APPLICATION NO.	FILING DATE	FIRST NAMED INVENTOR	ATTORNEY DOCKET NO.	CONFIRMATION NO.
10/626,729	07/25/2003	Vipul Patel	M4065.0912/P912	9706

Office Action Summary	Application No. 10/626,729	Applicant(s) PATEL, VIPUL	
	Examiner Dang T. Nguyen	Art Unit 2824

DETAILED ACTION

Fig. 2

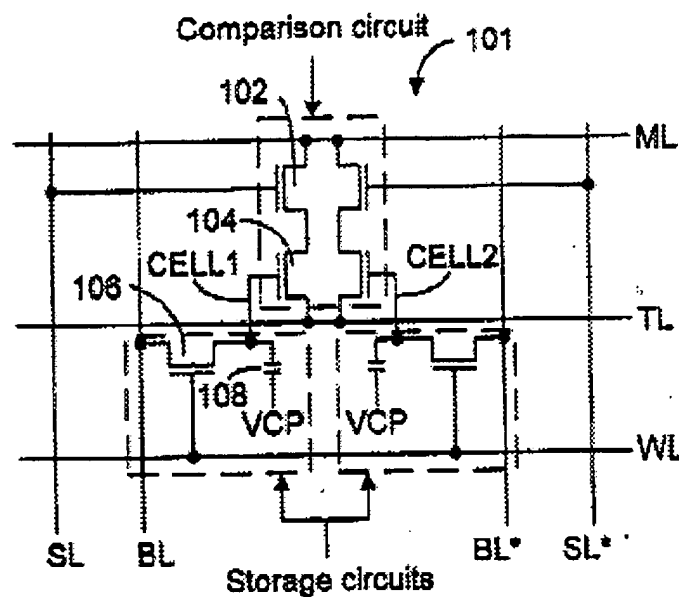
With respect to claims 1, 5, 18, 21, 28 and 35, under Remarks applicant argued: the "shieldline TL" of Gillinghan does not positioned between the matchline and the wordline; and the "shieldline TL" is being electrically separate from the matchline. Examiner respectfully disagrees from the following:

Fig. 2 of Gillinghan clearly discloses the shieldline TL is position between the matline ML and the wordline WL, and the shieldline TL is separate from the matchline ML by the electrical components 102 and 104; in other words, the electrical components 102 and 104 are using to disconnect/separate or connect the shieldline TL from matchline ML. Therefore, Gillinghan clearly discloses every aspect of claim invention.
